Re: The Need to Use Reasonably Foreseeable Future Flows in the Cache la Poudre River in the NISP Supplemental DEIS, With Regards to Declining C-BT Inflows

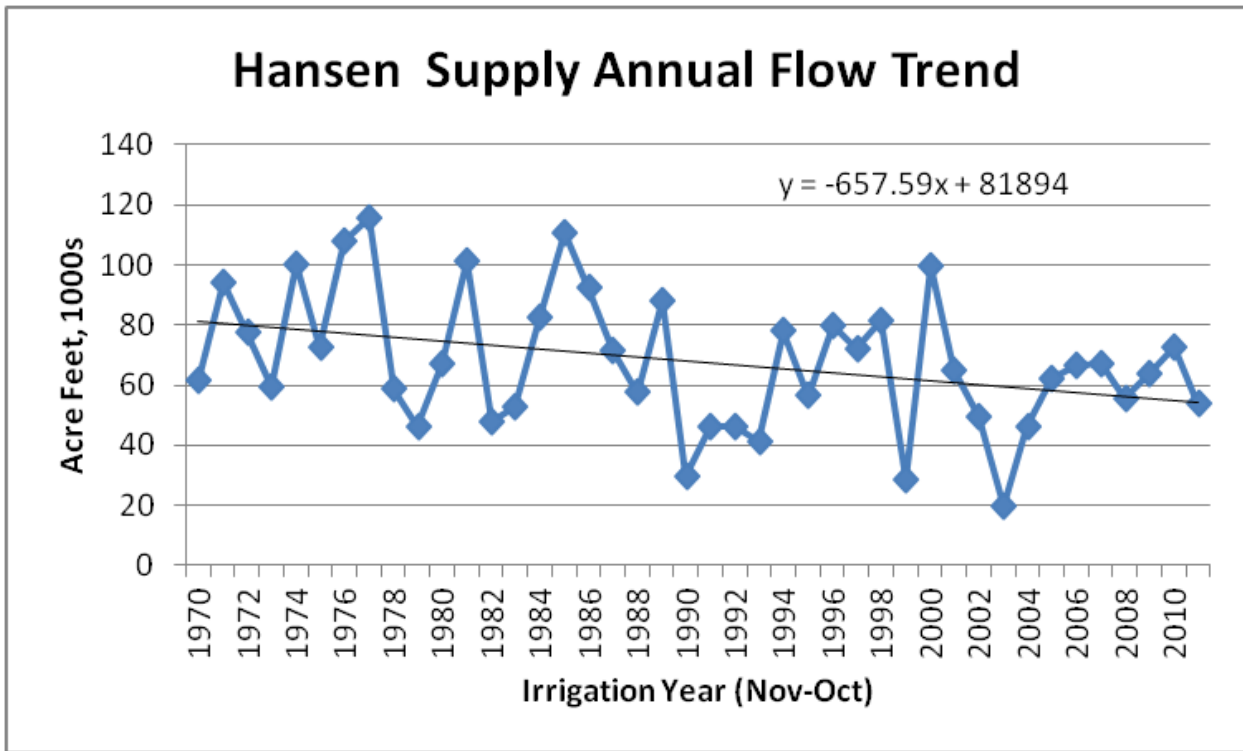
Rather than simply speculate on such a future, we have examined the flow records for water deliveries into the Poudre River above Fort Collins through the C-BT’s Hanson Supply Canal, the outflow from Horsetooth Reservoir. The 42-year graph shown in Figure 1 estimates the trend in water deliveries into the Poudre from the C-BT system

from 1970 through the current year. The linear trend illustrated estimates an average reduction in deliveries of 657 acre-feet per year, which would indicate a marked decline in deliveries should this trend continue over a 50-year planning horizon. Such a trend, of course, could be explained by changing climate, evolving storage and delivery policies, a reduction in agricultural deliveries, or some combination of factors. However, given that other consumptive agricultural water rights have been and will likely continue to be exchanged upstream for diversion from the river above Fort Collins, often to destinations outside the Poudre basin through the C-BT system and others, we believe that a reasonably foreseeable future for river flows through the City will be far different than the “baseline” used in the DEIS and result in legally significant impacts over and above those described in the DEIS.
